PLANNING BOARD REPORT

The Forefront at Thompson's Point, Portland, Maine
Thompson's Point, Portland, Maine
Level III Site Plan and Subdivision Amendments
2013-249

Submitted to: Portland Planning Board Public Hearing Date: December 17, 2013 CBL: 201-A-5	Prepared by: Nell Donaldson, Planner Date: December 12, 2013 Planning Board Report Number: #59-13
---	---

Figures 3, 4, & 5 (from top left, clockwise): Phase IA interim site plan; proposed elevations of renovated Brick North building; Phase IA site plan under the “stand alone” condition

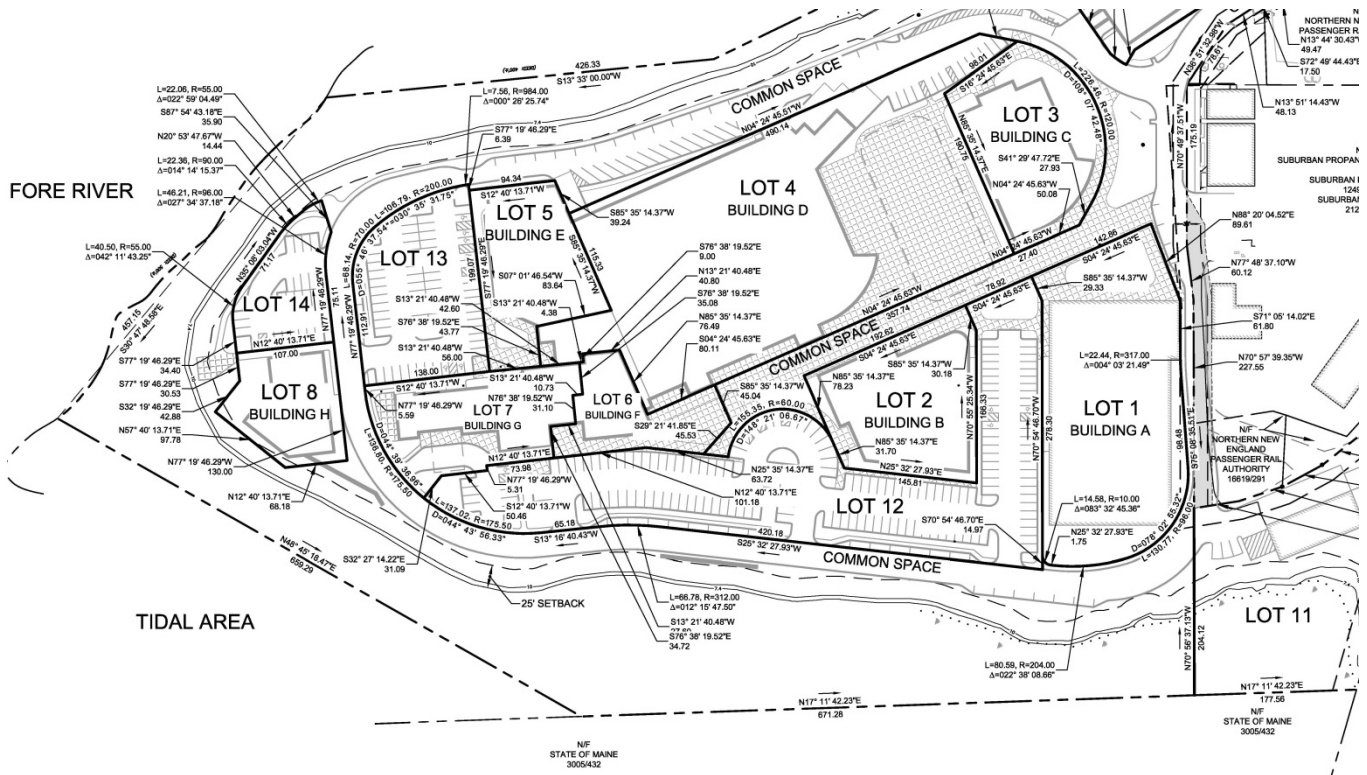
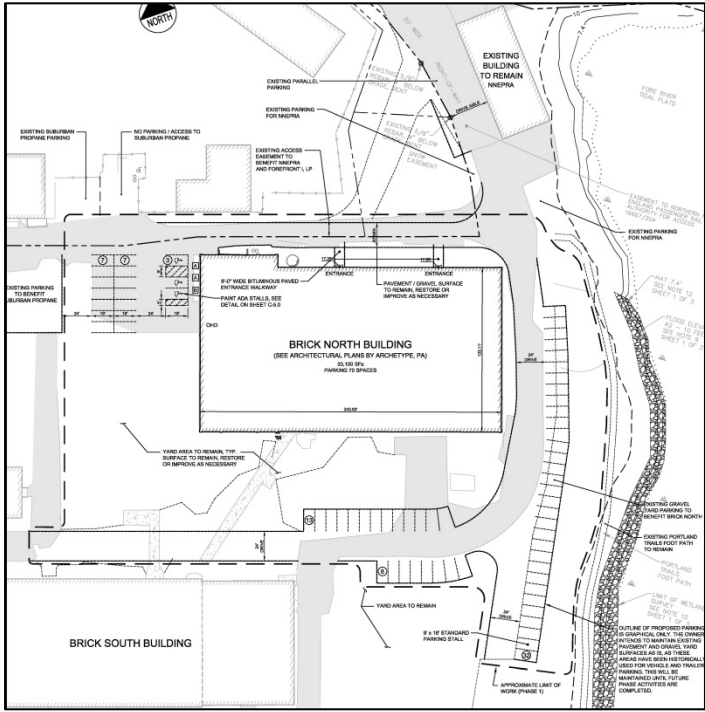
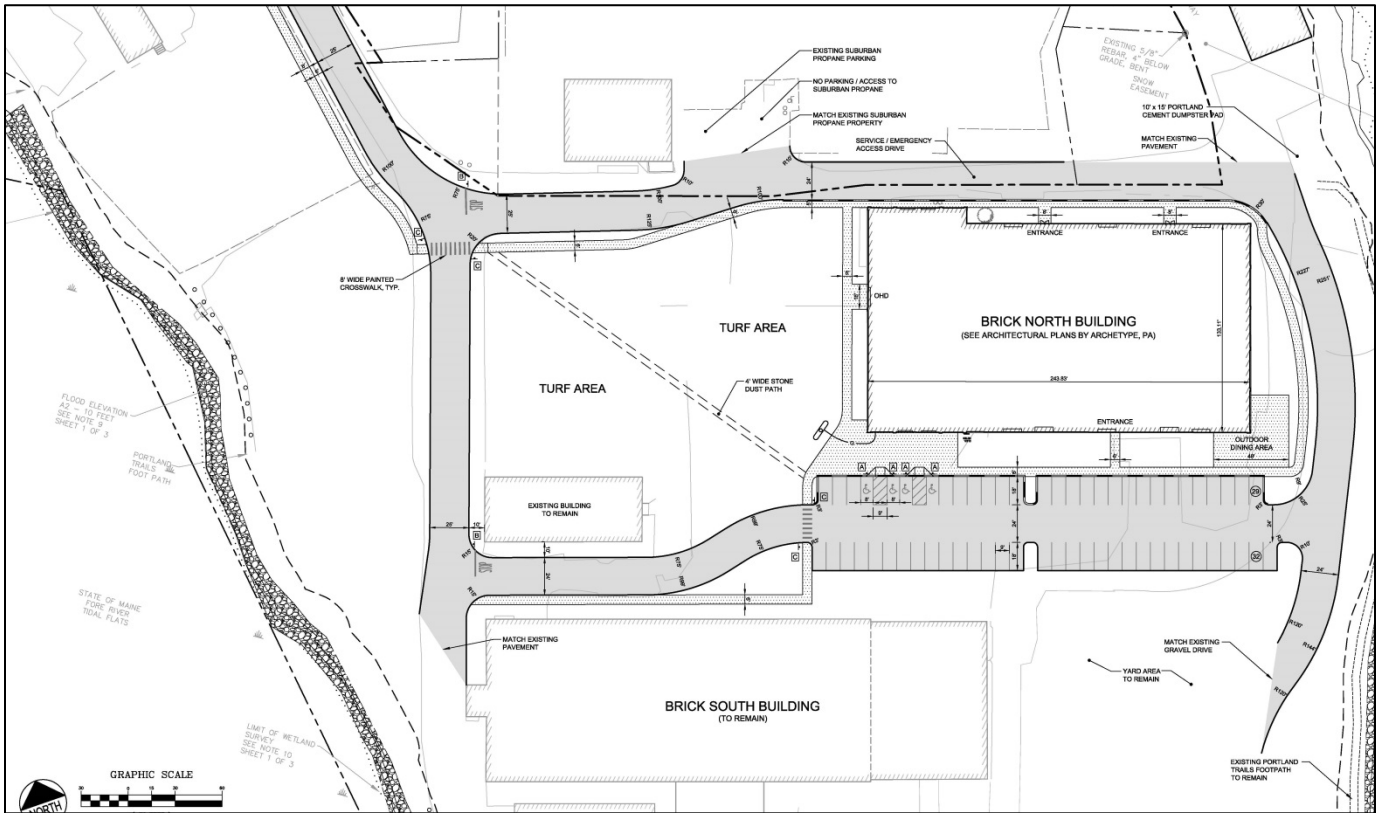
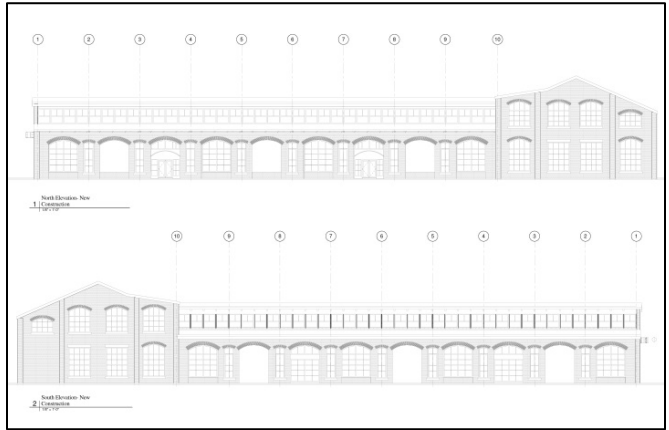
I have looked at the most recent proposal and the Site layout & utility plan. Based upon the provided information, it appears that this first building to be rehabbed as part of phase I will meet the parking demand. It would be helpful to back up the submitted information with floor plans showing the uses and their floor area. I am not sure that detailed information was submitted concerning the proposed phases and their time frames. It would help to review that information.

I have looked at the most recent submittals - revised 12/4/13 & uploaded to eplan on 12/9/13. The only thing that seems to have changed looking at the C-3.1 Site Layout Plan is the parking area. The plan is now showing 61 parking spaces provided which matches the 61 shown as required. Other than that I don't see anything else having changed from Marge's comments submitted on 11/27/13. She mentioned submitting floor plans showing the uses and their floor area to back up the submitted information. We have not received floor plans yet.

The existing approval issued by the City for the overall Thompsons Point project included approval for Site Location of Development (Site Law) under the City's delegated review authority. The interim plan and the "Stand Alone" plan do not address Stormwater Management Law under Site Law. Given the anticipated interim nature of the site plans, and given that a stormwater management approach to address Site Law would require comprehensive modeling, design, and interconnected infrastructure with areas of the site that will not be improved in this interim period, it is understandable that the applicant does not propose significant stormwater infrastructure modifications in this interim period. I understand that the City will add a

The interim plan should meet all ADA accessibility requirements for access to the building. The applicant shall confirm that the site is compliant.

A crosswalk shall be added at the first intersection entering the site under the stand alone plan.

Bicycle parking shall be provided for both interim and stand alone plan conditions.

4. The applicant shall revise the site plan to include:
 - a. A crosswalk in the specified location under the stand alone condition;
 - b. Bicycle parking in quantities as required by the site plan ordinance;
